# Service Information

Category <b>R</b>	<b>Repair Guidance</b>	Ref. No. R114/15 <b>B</b>	Page 1 of 4
Coverage <input type="checkbox"/> Distributor only <input checked="" type="checkbox"/> Please inform your dealers		Date Issued December 8, 2015	
Please convey this information to your <input type="checkbox"/> Director <input checked="" type="checkbox"/> General Manager <input checked="" type="checkbox"/> Warranty Dept. <input checked="" type="checkbox"/> Parts Dept. <input checked="" type="checkbox"/> Training Dept. <input checked="" type="checkbox"/> Field Rep.		Date Revised July 14, 2016	
Applicable Model  CX-3 (DK)		Applicable Countries or Specifications  Worldwide

## Subject: Creaking noise from front shock absorber

### Protector Installation Procedure

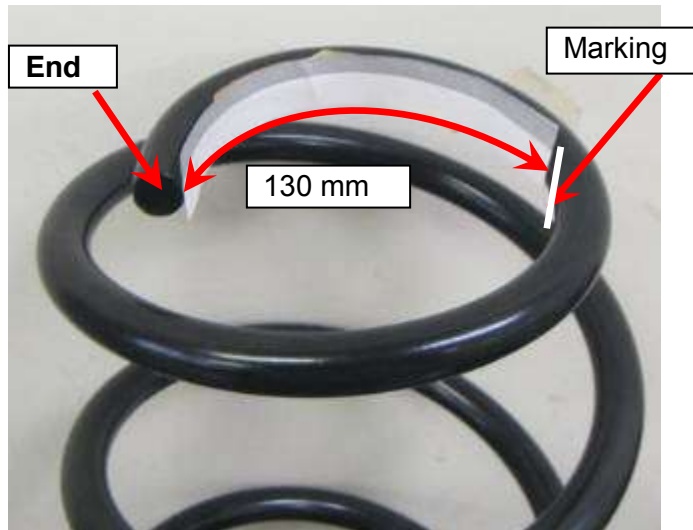
- 1) Degrease 1.5 turns of the spring from the top.
- 2) Cut a piece of paper of 130 mm length to use as a measure. Place the paper along the inner side of the coil spring and put a marking as shown in the figure.

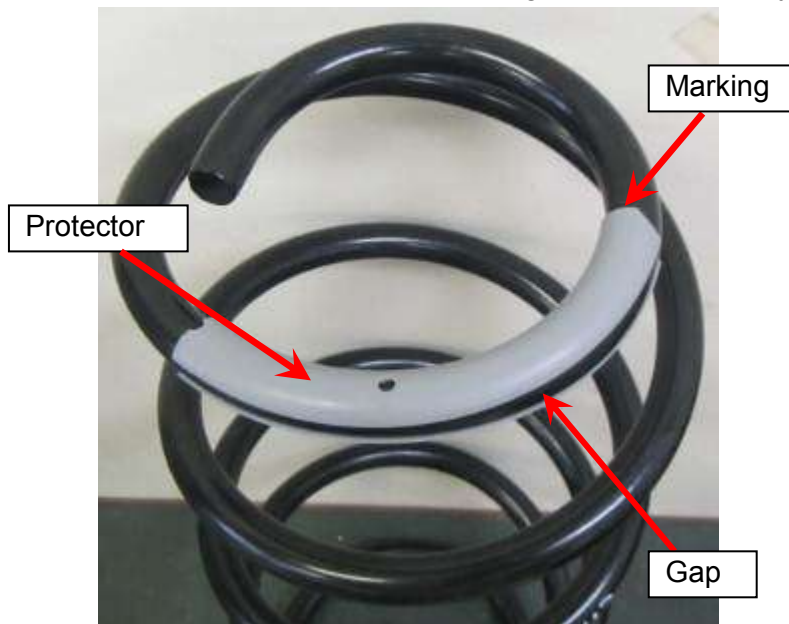
- 3) Install the protector to the coil spring aligning the end of the protector (slant cut side) with the marking as shown in the figure.

**NOTE:** Install the protector so that the gap becomes evenly.
